Memorandum

TO: DARREN AMUNDSEN, DICK FOSTER	PROJECT: ENCLAVE OF MEDINA	DATE: JUNE 9, 2010
FROM: MARK JANOVEC	CLIENT: CITY OF MEDINA	
RE: PROPOSED ENCLAVE IRRIGATION WELLS	FILE NO: 190-10000-1

The proposed installation of high capacity irrigation wells at the Enclave of Medina development required an analysis to determine if potential drawdown interference from these wells is likely to impact the adjacent City of Medina well field. At present, the Enclave development proposes to install six total irrigation wells, including five high-capacity wells pumping approximately 420gpm each and one medium-capacity well pumping 40gpm. The locations of the proposed wells are shown in Figure 1. The 420gpm wells will have an average run time of 2.5 hours, three times a week. The 40gpm well will have an average run time of 13.5 hours, three times a week. All six proposed wells are likely to be installed in the Jordan sandstone aquifer.

TABLE 1 : PREDICTED DRAWDOWN INTERFERENCE - MEDINA JORDAN WELL FIELD AND ENCLAVE DEVELOPMENT

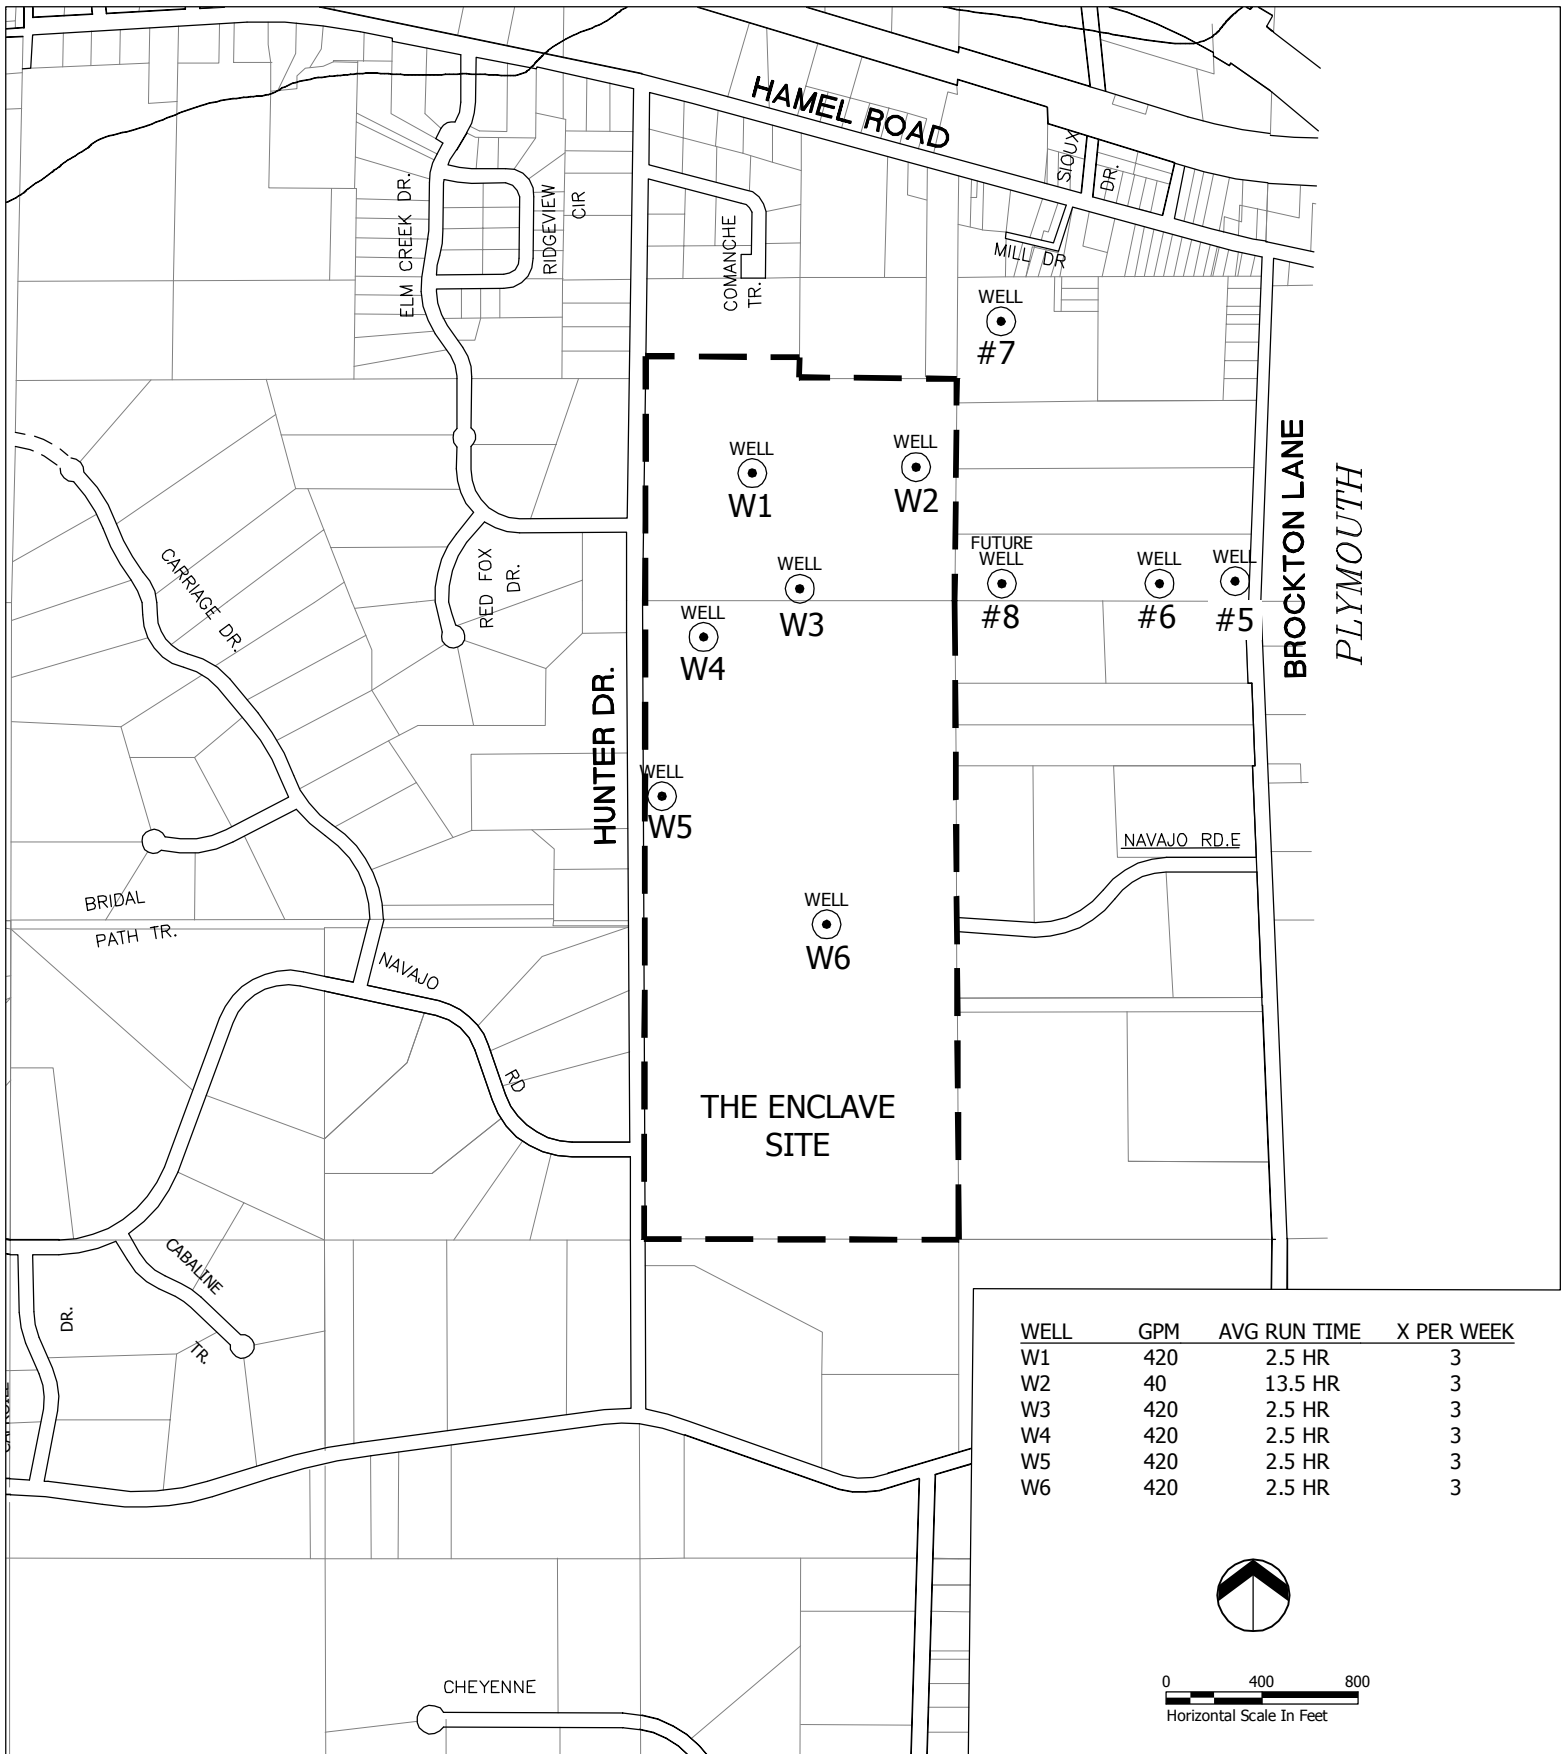
The results of the modeling effort are displayed in Table 1. The predicted total drawdown at the City of Medina wells, under this scenario, ranges from 85-103 feet. This includes 11-12 feet of additional drawdown created by the proposed Enclave wells. This additional drawdown could reduce the efficiency of the Medina wells somewhat (resulting in higher operating costs to pump the water). Overall, the predicted total drawdown is still expected to be somewhat less than the available drawdown of 150-160 feet at the Medina well field. As such, there appears to be sufficient hydraulic head in the aquifer to accommodate the additional drawdown.

The Enclave wells are predicted to have drawdown of approximately 84-99 feet after 24 hours of continuous pumping. It is unlikely that such a pumping scenario will take place at these wells, since actual pumping periods are expected to be much shorter. However, the actual performance of the Jordan aquifer within the Enclave development cannot be truly known until wells are installed and aquifer tests are conducted. If the aquifer performance at the Enclave wells is worse than observed at the Medina well field, the actual observed drawdown could be greater than predicted. Additionally, the performance of the Medina wells was only obtained after careful and thorough development of the well after drilling. If less care is taken to develop the Enclave irrigation wells, the actual well performance could be worse than predicted by the above analysis.

1. The City of Medina should tentatively design future Well 8 to handle at least 100 feet of drawdown under operating conditions. Upon completion of the drilling and development of Well 8, an aquifer pumping test should be conducted on this well to verify that the performance of the Jordan aquifer at this location is consistent with Well 6 and Well 7. An aquifer test will not only help refine the results of this analysis, but will also help in selecting the optimal pump size and setting for this well.

2. The Enclave of Medina developers should take measures to ensure their irrigation wells are properly and fully developed, to increase well performance and reduce drawdown during operating conditions.

3. Since the modeling analysis presented above is based on assumptions of aquifer homogeneity, the Enclave of Medina developers should consider conducting aquifer performance tests on at least the first two high capacity irrigation wells to be installed. These aquifer performance tests will not only help to verify the performance of the Jordan aquifer within the Enclave development, but will also help to refine the predictions of drawdown. Both Medina and the Enclave development will benefit from having this data available.
